Longford Park – Country Park Landscaping Amendment Commentary

By: Taylor Wimpey UK

Dated: 23/05/2022

This report is to accompany the revised landscape drawings for Longford Park. The below will identify changes and the reasons for the changes.

5205/ASP/CP.PP4.4 Rev H

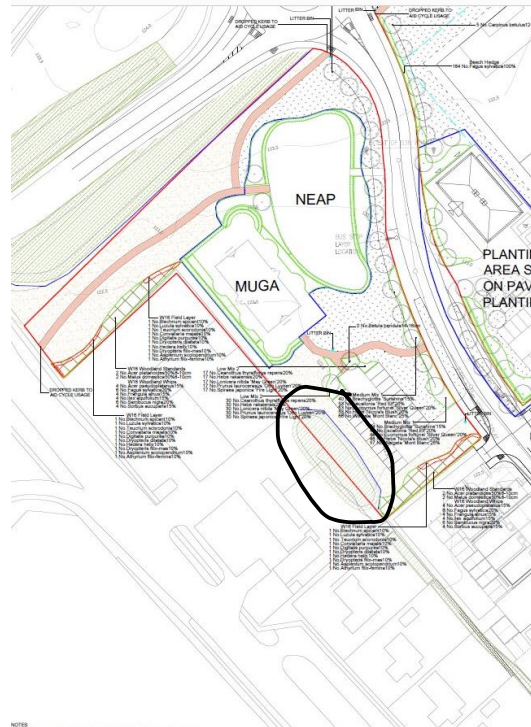
Within the NEAP area it has become evident that the children taking the shortcuts straight through the long grass (*Miscanthus sinensis* 'Siberturm') flowerbeds or using them as run off from play equipment. We have made the decision to change some of these areas over to a turfed finish, as we felt that replanting the plants has been proved not to be a practical option due to inability to establish in this area. The other benefit of the change is offering better options on maintenance the below pictures shows the before and after turfing. We also run this by personnel from Banbury town council as the end user as they happen to be with us on a day we were looking at this area.

5205/CP-ASP2.4 rev Z, 5205/CP-ASP2.5 rev Z and 5205/CP-ASP2.3 rev Z

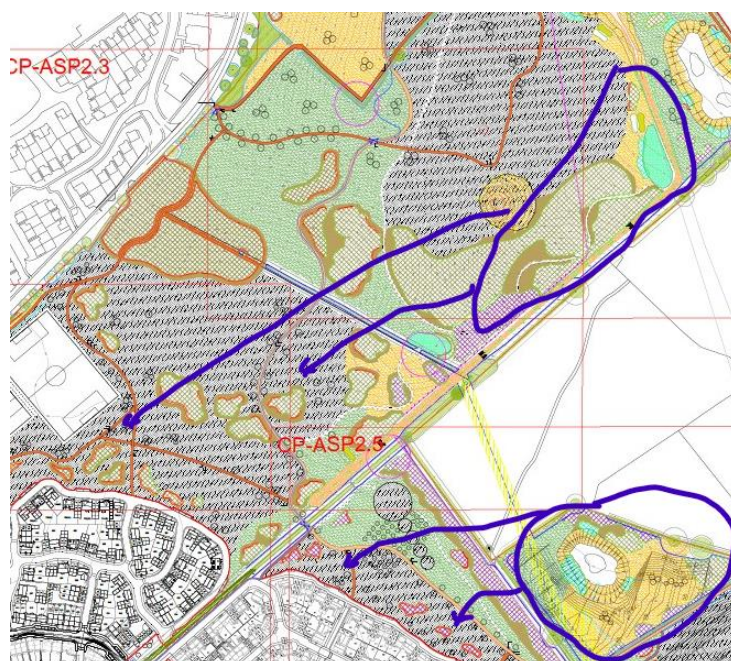
Through the period that the field layer has been installed within the country Park it has become evident that certain field layer beds have not survived where other field layer beds have had high number of plant survival.

Where the beds have not had high number of plant species surviving, are areas with low foot traffic from the general public also had higher signs of animals with in these areas.

Through discussion with a member Cherwell District Council, we have concluded to move a number of the field planters to other field layer beds to increase the potential of survival and reduce the complications of future maintenance.

The drawing below shows a rough area where we are moving the beds from and planting the field lays plants that have not taken. The field lays beds numbers be increased along areas with a higher footfall to the public with most of the beds being beside occupied plots and paths.

We feel that that this will offer better enjoyment to the public walking through the country Park rather than being in areas of low foot traffic. The other benefit of moving the field layer is that avoids maintainece problem by them being cut when grass cutting as they are surrounded by wildflowers areas.

5205/ CP – ASPA 2.1 revision Z and 5205/ CP – ASPA 2.2 revision Z

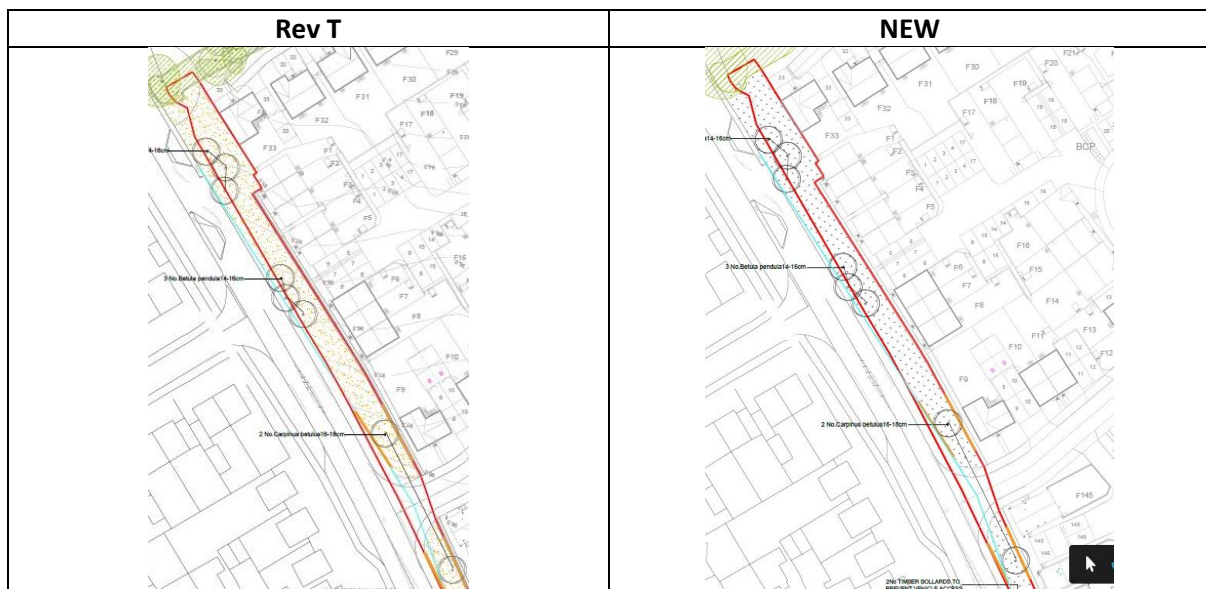
At the front of site revision T we had wildflower grassland to be installed. At time of sales offices were open by Taylor Wimpey and Barrett's installed turf along the front of the site to allow for suitable presentation of the entrance to the site.

As we currently feel it enhances the appearance to the entrance of Longford Park phase 4 we were reluctant to change back to wildflower and have made the decision to change the drawings to turf. Which is in keeping with other developments along the Bankside Road.

Central bank through the site

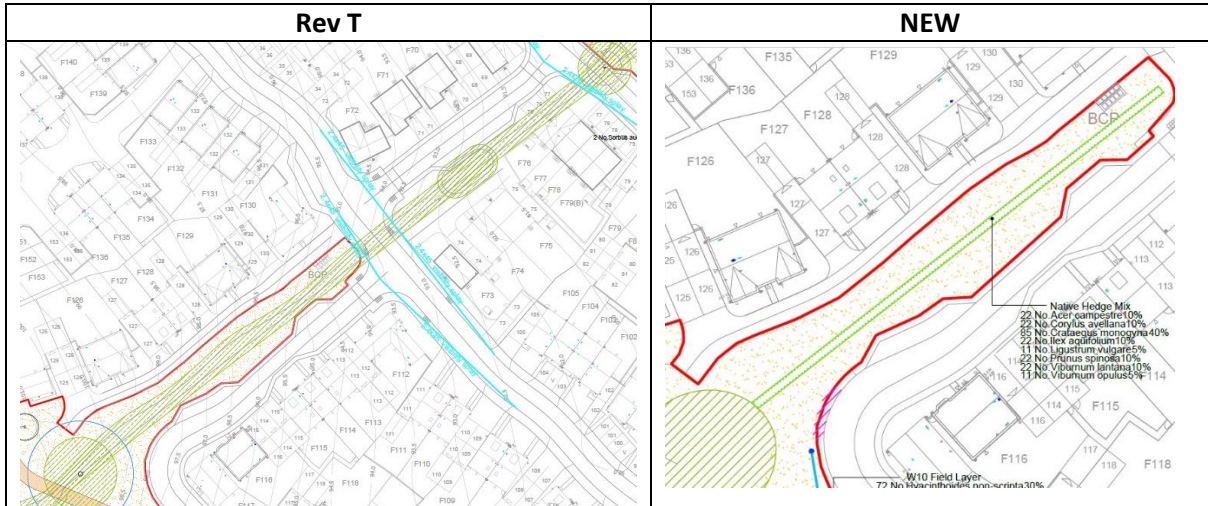
The approved drawing revision T incorrectly showed an existing hedge running right through the site including across hardstanding areas. This was incorrect and should have fully been removed at an early stage.

To help with bringing back diversity within the site and allow an enhancement of the landscaping we have corrected this area and have asked for a native hedge species to be installed within the wild grass area.

Swale

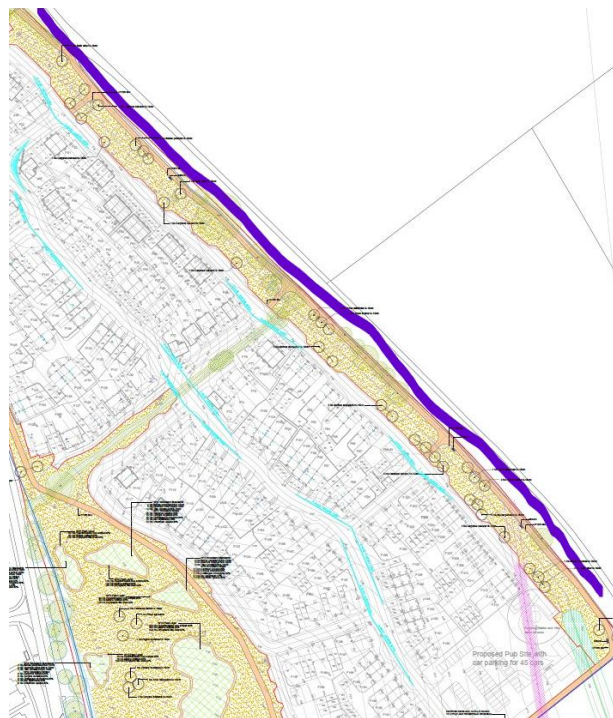
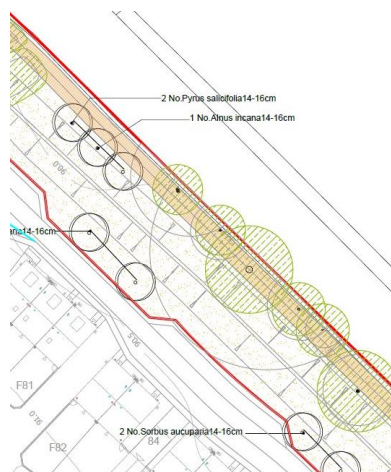
The current approved drawings revision T along the canal as marked above to be planted with wildflower seeds. Due to the banks in this area, we feel that it is unlikely that will manage to get wildflowers to take and have risk of any seeds being washed away. As the swale has been created for over a year, we have found that natural flora and fauna has taken picture bellow. So we have

liaised with relevant party at Cherwell District Council to agree a solution which will not involve us scraping back the existing vegetation to the earth. The solution we believe will help keep residents happier and keep the ecology in this area.

The solution that we have now come up with is to pod plant number of species at a suitable spacing throughout the area. We have also changed the species to be in line with the suggestions that were made from Cherwell District Council rather than install the species as listed in the wildflower mix.

The position of the Hogging cycle path as shown on approved drawing revision T has been moved from one side of the swale near the canal to the other as shown in the above picture. Reason for moving path is that we could not achieve a 2 m path width on the that side due to number of TPO trees being located (shown bellow) along the side of the canal. The levels would have put it at risk of flooding and additional maintenance. By moving the swale and installing the knee rail we have now made to cycle path safer for children to use as we have now removed the water hazard being right beside the path.

Spring

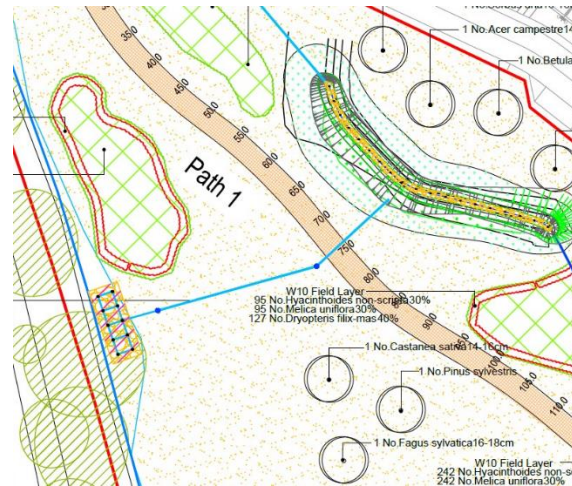
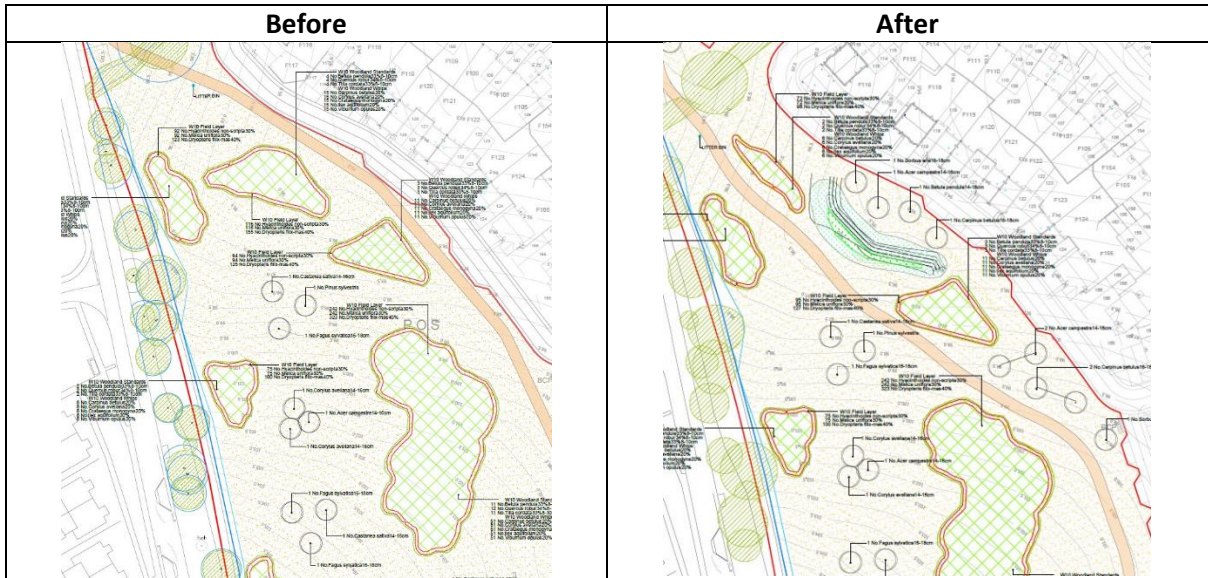
We've had to install interceptor drainage features to capture the spring water that is flowing above the ground level in the area along Bankside Road. As part of the country park profiling works, the groundworks contractor have identified a total of seven springs along this area, which were not previously identified by the various site investigations. The interceptor swale shown below is required to prevent said spring water from flowing onto the road causing a health and safety issue.

Several alternative solutions were reviewed to deal with the spring water, which included an option to drain directly into the surface water sewer network on site. However, it was confirmed that the network did not have capacity to take any additional flows. Therefore, the only suitable solution has been to capture the flows via the interceptor swale, and then direct them to an evaporation basin sited away from any highway or homes, with an overflow solution which would ensure that any overflows would be conveyed into an existing swale within the country park before being discharged in line with our existing surface water strategy.

During construction of the interceptor swale our groundworks contractor identified that the spring water was also flowing laterally and breaking through the ground at the lowest point, directly at road level. As a result, they made the decision to deepen the trench beyond what was shown on the design. Whilst this should have been agreed/discussed, it has provided the necessary interception required, and we have subsequently amended our designs to maintain this functionality whilst retaining a shallow depression at the surface. The latest design also deals with an additional spring in this location.

Due to the various springs in this area, we have also altered the locations of the planting beds to try and move them away from areas where the soil will experience waterlogging.

Additional drainage ditch

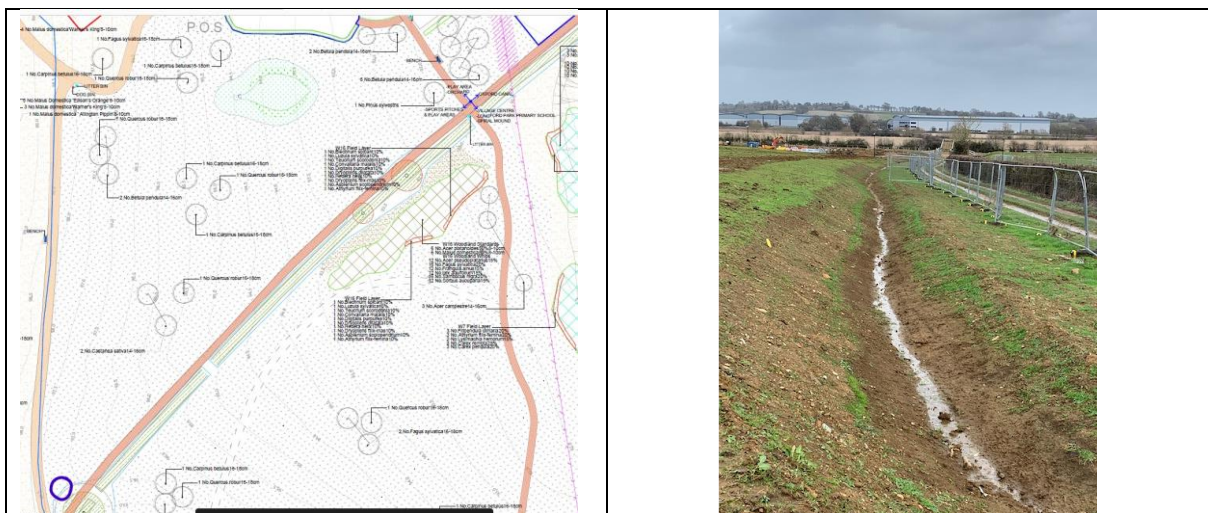
After profiling of the country Park and installation of the path on phase 4, another spring was identified, and highlighted of the extract below. To mitigate this, we have had to put in an additional ditch to stop additional water ending up on the farmers track and divert it down to the existing swale network, to help mitigate the farmers track having so much water on. We have also noted on recent walk around that we may need to put additional drainage in.

Tarmac Cycle Path

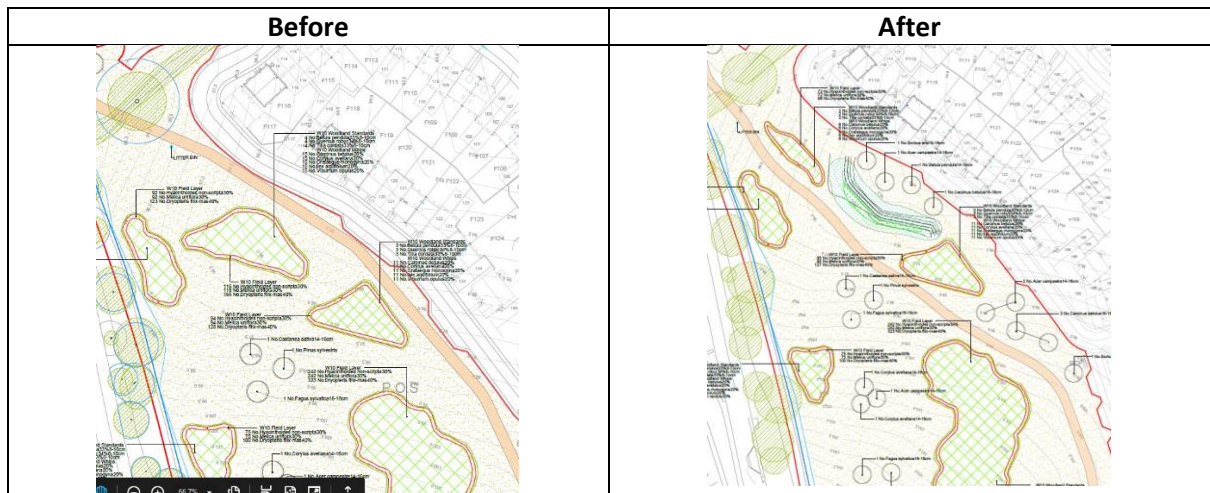
The route of the cycle path has been altered, as the original design had not taken into consideration the excessive gradients which would have been required to achieve its position on the bank, making it both unsuitable for certain pedestrian users and also posing a potential H&S risk due to the fact the steeper sections were orientated in the direction of the road. In order to meet necessary standards, both Cherwell and OCC were consulted, and the route of the path adjusted to suit feedback. This new route also avoids the root protection zone associated with the adjacent oak tree.

Though we are aware that moving the path may cause concerns from residents with regards to pedestrians overlooking the adjacent properties, we have taken the reasonable steps to mitigate this by moving some of the woodland stands to the side of the path to provide a screen. Additional trees have also been introduced in front of the interceptor swale, mentioned above, and further up the bank which we believe will provide further screening/betterment.

As you are aware, extensive earthworks have taken place across the entire country park. With regards to the area shown above, there are some instances whereby finished levels are slightly lower or higher than the proposed levels shown on the designs, but these small discrepancies act to cancel one another out. To confirm, less soil had been generated from Phase 4 than was originally calculated, meaning that less soil was available for profiling the area shown above and has resulted in this area being lower overall when compared to the design proposals.
